PCD File # PPR2227

LANDSCAPE PLAN

Landscape Plan Drawings_V2.pdf Markup Summary

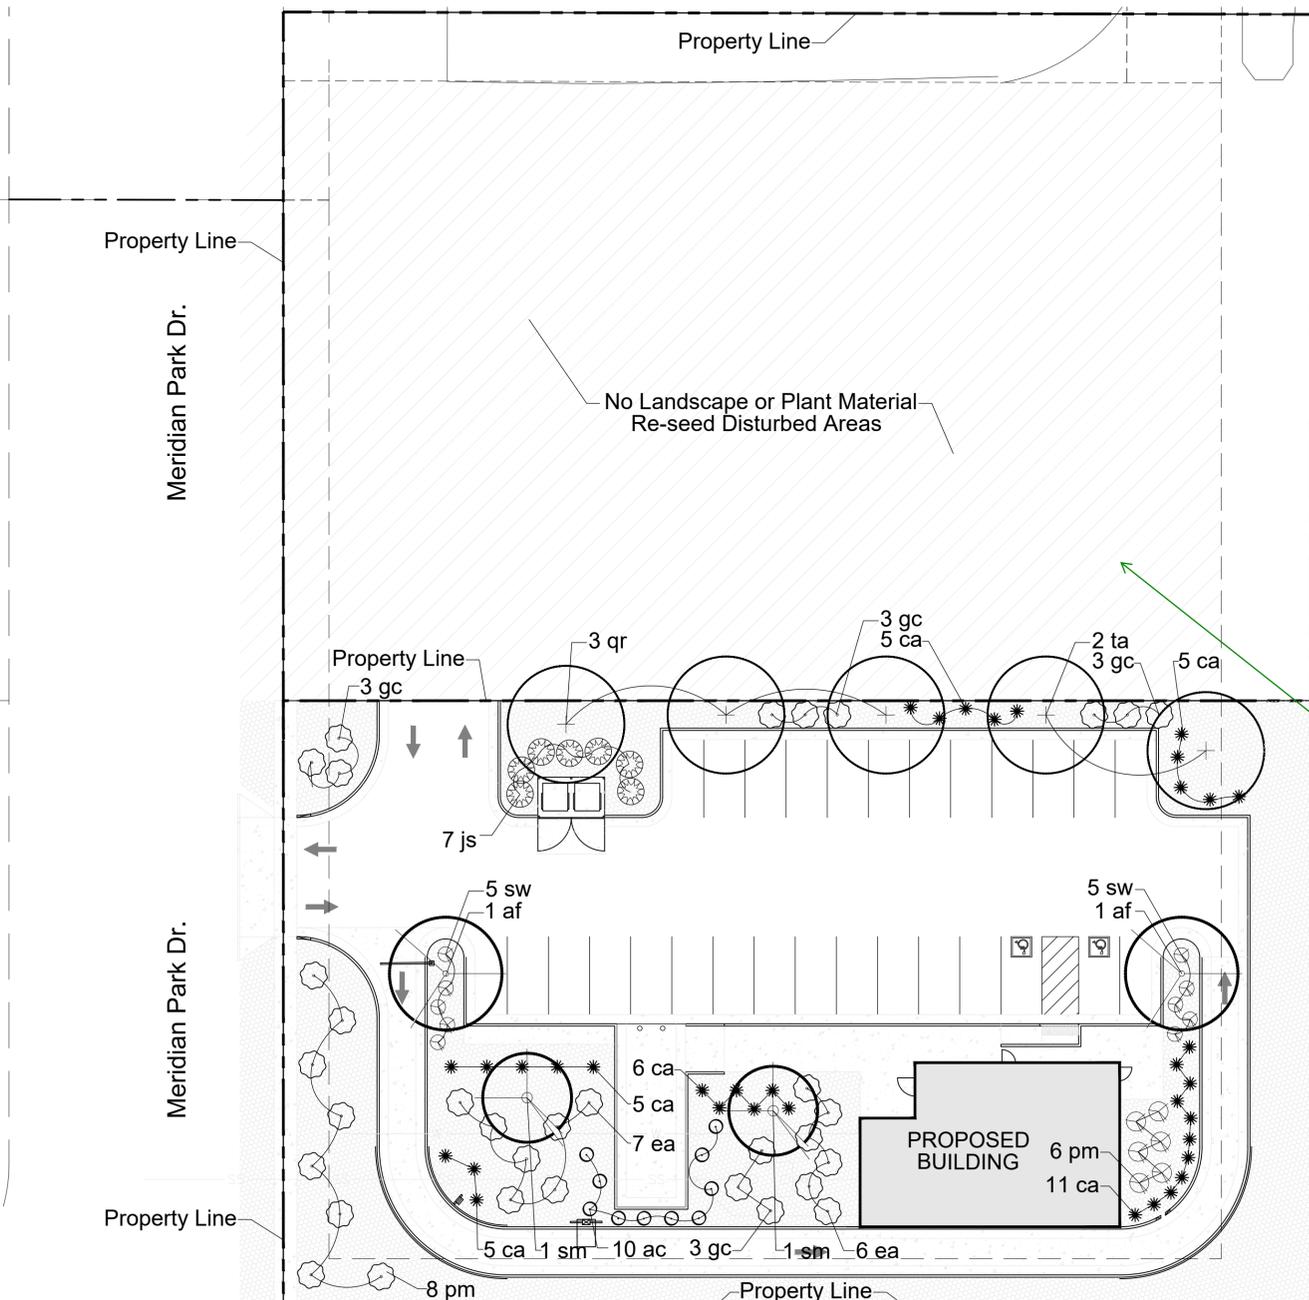
Please see comments on Landscape Plan provided in the Site Development Plan set V2. Please make sure the correct plan is incorporated into that set, or remove from the set.
